PCN# : P57DAAB
Issue Date : Jul. 20, 2015

Information Only Notification

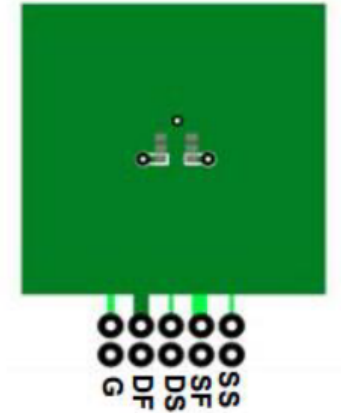
Description of Change (From) :
Old thermal board images in datasheet (Page 2)

New thermal board images in datasheet (Page 2)

Reason for Change:
Update thermal board images to match the board used in test.
